**PLANNED UNIT DEVELOPMENT****Date: July 21, 2016****DEVELOPMENT NAME**

Volunteers of America

Planned Unit Development Approval to amend a  
previously approved Planned Unit Development to allow  
multiple buildings on a single building site along with  
shared access *and parking and Planning Approval to allow  
an expansion of an existing church in an R-3, Multiple  
Family District.*

**Planned Unit Development:** Based upon the preceding, this application is recommended for Holdover until the August 18, 2016 meeting, with revisions due by Tuesday July 26, 2016 to address the following:

SITE PLAN

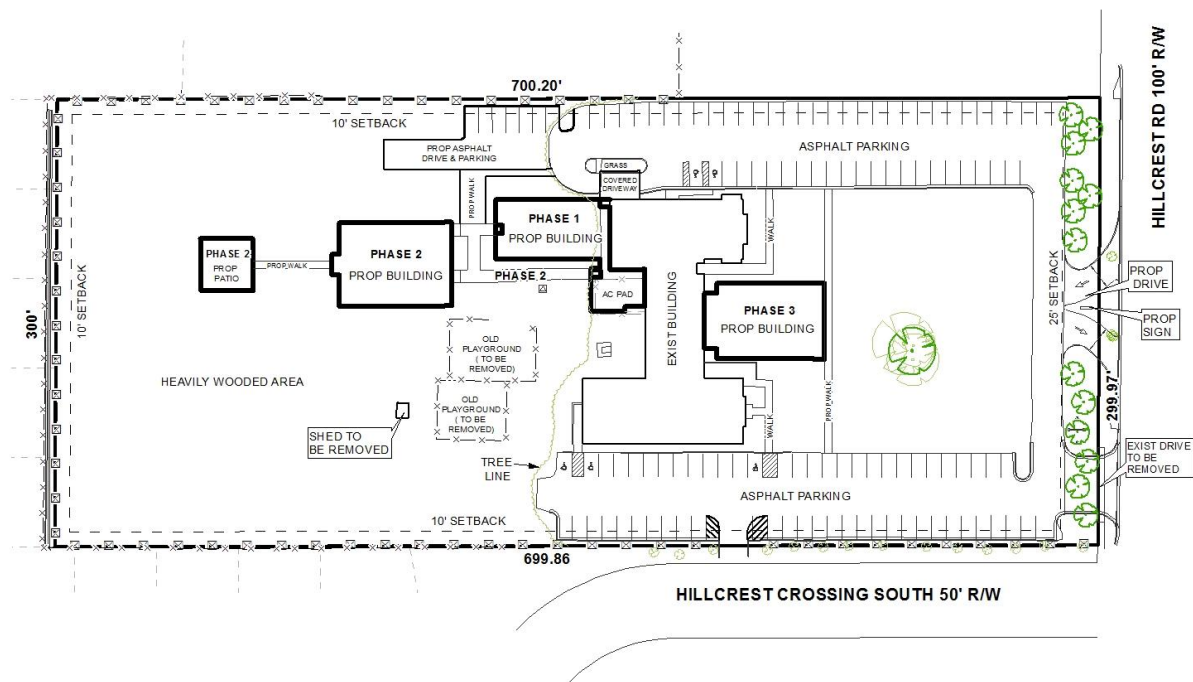
The site is currently developed as a church with associated on-site parking. The applicant proposes to construct three major additions to the site which will be developed in three separate phases. The patio addition will be a part of the second phase. It should be noted; the first and third phase as mentioned in detail in the previous report will remain the same. The size of the patio in square is not depicted on the site. The site plan should be revised to illustrate the total square footage of the patio.

It should be pointed out that one of the changes to the PUD included tree planting. The previously approved site plan depicted a variety of proposed understory and overstory trees within the front of the property between the phase 3 two-story building and the front setback; however the revised site plan no longer depicts the additional trees. There are sufficient existing trees that will remain on-site to satisfy all but the frontage tree requirements.

The total amount of proposed tree plantings and landscaping calculations are illustrated on the site plan. However, it appears that the total perimeter tree credit calculations provided cannot be verified or reproduced by staff. Although it appears that full tree and landscaping compliance is possible, staff cannot accurately determine the total number of tree credits based on the plan

submitted. The site plan submitted for Land Disturbance must clearly identify and depict the trees claimed for tree credits. The site plan should be in full compliance with Section 64-4.E of the Zoning Ordinance.

The site plan depicts what appears to be a compliant number of total parking spaces for the site. All parking must be in compliance with Section 64-6 of the Zoning Ordinance.

The site plan depicts a 6' high wooden privacy fence as well as a 10' minimum residential buffer where the site abuts residential property. This note and information should be retained on any future site plans.

A sidewalk is depicted on the site plan and should be retained on the site plans.

There is no dumpster illustrated on the site plan, however there is a note on the site plan that states "*No trash dumpster is required. Carts will be utilized for trash disposal.*" This note should be retained on any future site plans.

It should be noted, the metal shed on skids was illustrated as "to be removed" on the previous site plan, however the new site plan does not reflect those changes. If the shed is going to be removed the site plan should be revised to depict it.

- 1) the submission of a Planning Approval application;
- 2) revision of the site plan to depict the metal shed on skids with a note to be removed if it is indeed going to be removed; and
- 3) revision of the site plan to depict the square footage of the concrete patio.

*The revised plan shows the 1,225 square feet patio, which will act as a “place of refuge” in order to meet Building/ Fire code requirements. Furthermore, an elevator once proposed for the two-story building in Phase Two was removed, thus changing the buildings footprint. The previously approved uses will not be changed.*

***Planned Unit Development:*** *The application is recommended for approval, subject to the following conditions:*

- 1) retention of the lot size in square feet and acres;*
- 2) retention of the minimum building setback lines;*
- 3) submission of building permits for each phase of development;*

- 4) retention of the 6’ wooden privacy fence where the site abuts residential property;*
- 5) placement of a note on the site plan stating that tree removal shall be limited to the project area;*

- 6) retention of all notes on the site plan;*
- 7) compliance with Engineering comments: “No comment- all required notes are on the submitted drawing.”*
